BGA TECHNICAL COMMITTEE

TECHNICAL NEWSHEET 01/02/00

PART 1 AIRWORTHINESS "AGGRO" Herewith the Millennium "GREEN" Issue of the BGA Compendium of Airworthiness Directives, Mandatory Modifications, Special Inspections and Check List of Defects.

Fig. 1

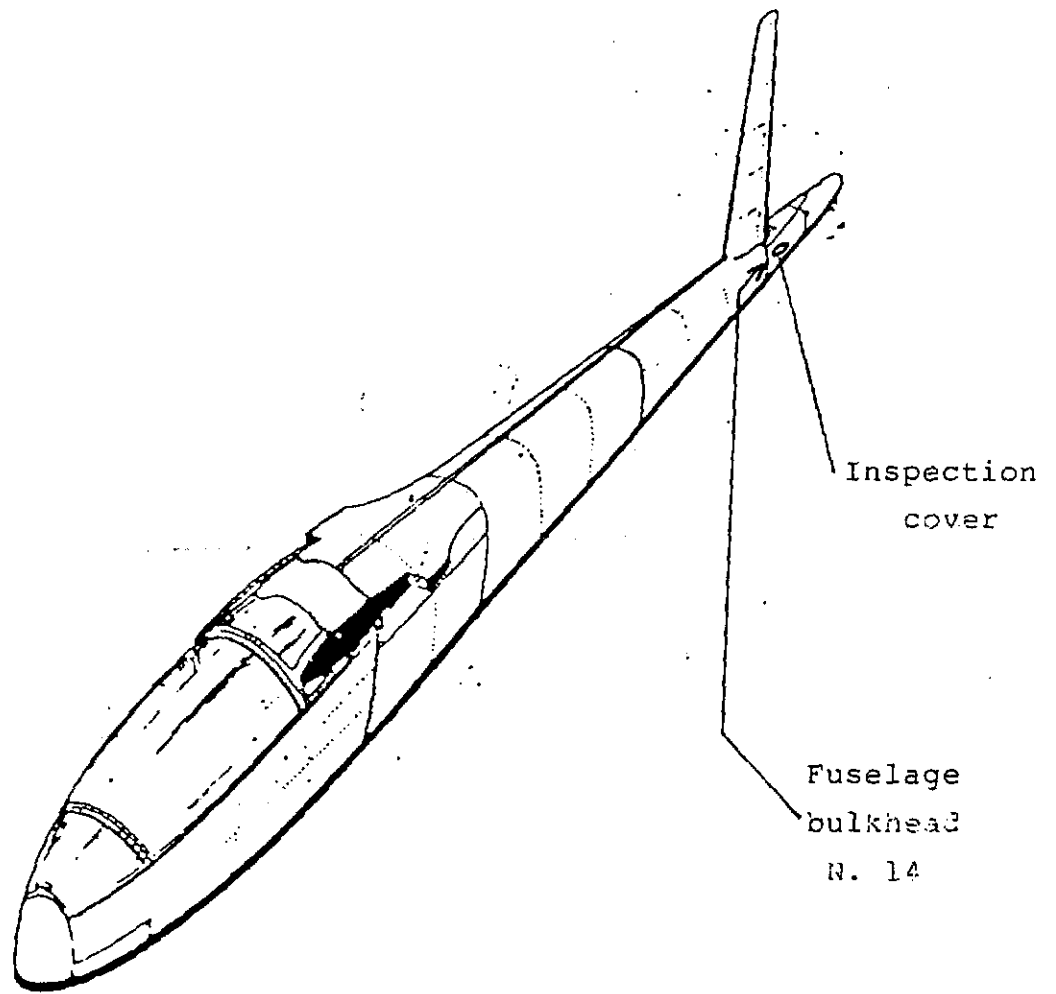
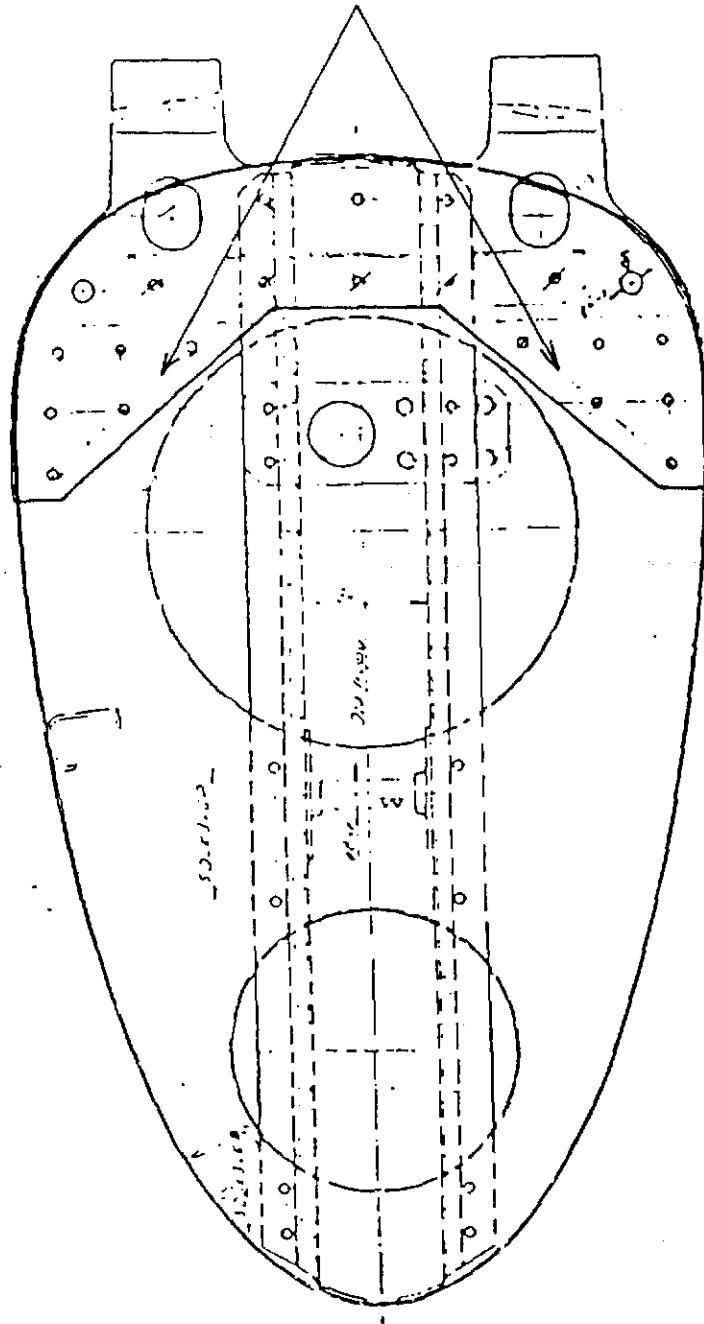
Reason: On the L 13 BLANIK sailplane S/N 027226, the tail-fuselage attachment fitting P/N A 102 021 N made of 424253.11 material has been damaged in service.
The material of this component must be tested as instructed in this Bulletin.

1. Remove the oval cover located on the LH side of the fuselage, under the horizontal stabilizer.
2. Test the material of the attachment fitting P/N A 102 021 N as follows:
 - a) Conductivity measurement by means of eddy currents:
 - Recommended measurement frequency: 60 kHz
 - Probe diameter: not exceeding 15 mm
 - Measuring contact point: lower milled surface of the component, between the rivets (see Figs 1 and 2).

- b) Hardness measurement by means of a portable digital hardness tester.
Measuring method: depending on the type of the hardness tester used, i.e. dynamic, ultrasonic, and/or by means of a manual probe.
Measuring point: lower milled surface of the component.
Measured value: not lower than 100 HB.
- c) Any other measuring method must be approved by the sailplane manufacturer before it can be used.

- 3.1 If the values measured during the check are within the permissible limits specified above, make a record in the sailplane logbook (see section H of this Bulletin). The sailplane operation can be continued without any limitations.
- 3.2 If the values measured during the check are not within the permissible limits, the attachment fitting P/N A 102 021 N must be replaced before the sailplane operation can be continued.
4. If the attachment fitting P/N A 102 021 N is to be replaced, the operator shall place an order with the manufacturer, stating the sailplane Serial No., number of flight hours, registration mark, and number of its repairs and / or overhauls.
5. The manufacturer will send to the operator the material required for replacement, together with a bulletin providing the work procedure.
6. After the check, reinstall the inspection hole cover.

DEFECT REPORT.

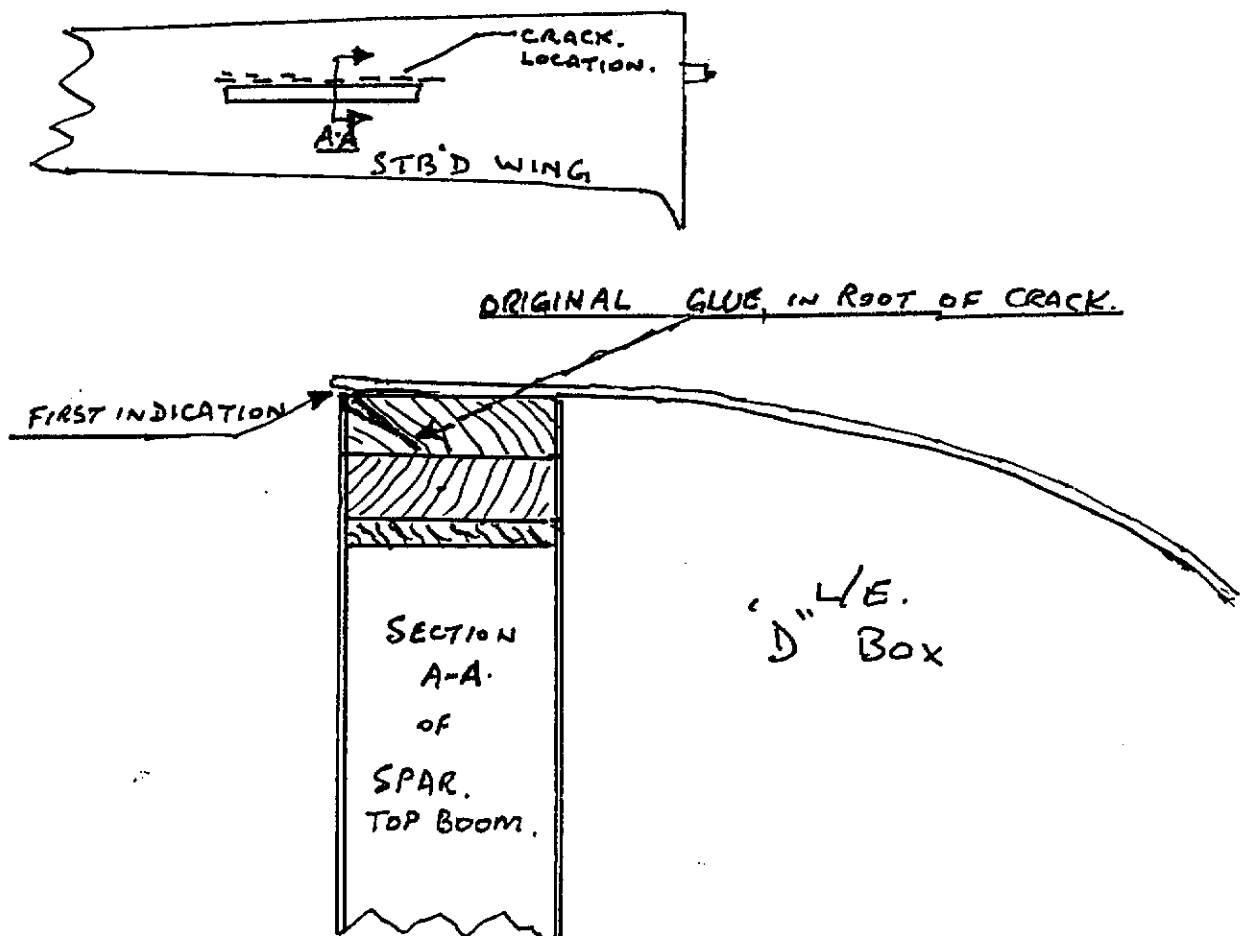
During the course of inspecting the above glider, it was observed that the port top airbrake paddle was approx: 1/4" below the top skin profile. Closer examination revealed a splitting of the top mainspar boom over a length of 30 inches immediately ahead of the airbrake slot under the D-box skin. A thin blade could be inserted 1/2" to 3/4" without resistance along the length of the separation in the spar boom.

The glider has not been involved in a heavy landing or in any aerobatics. It has been owned by the same syndicate for a long period. When flown at other gliding sites it has been left rigged on occasions.

Over the 10 years I have known the glider, it has been cared for and not abused. The starboard spar does not show any evidence of a defect. Inspection of a younger K6 E for any defect in the same area showed no problem.
